Product Change Notice (PCN)

PCN Number: PCN-0450375R-01

Product(s) Affected: PD-30S

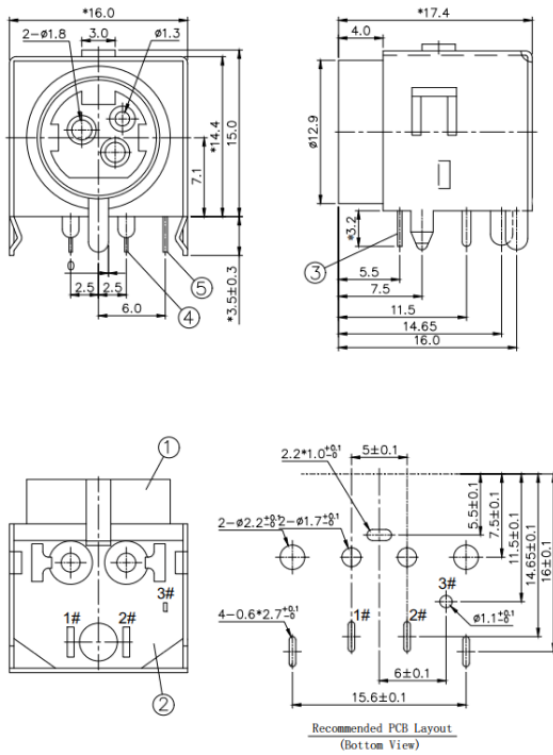
Description of Change: Small dimensional changes, shown in the drawing below

OLD

NEW
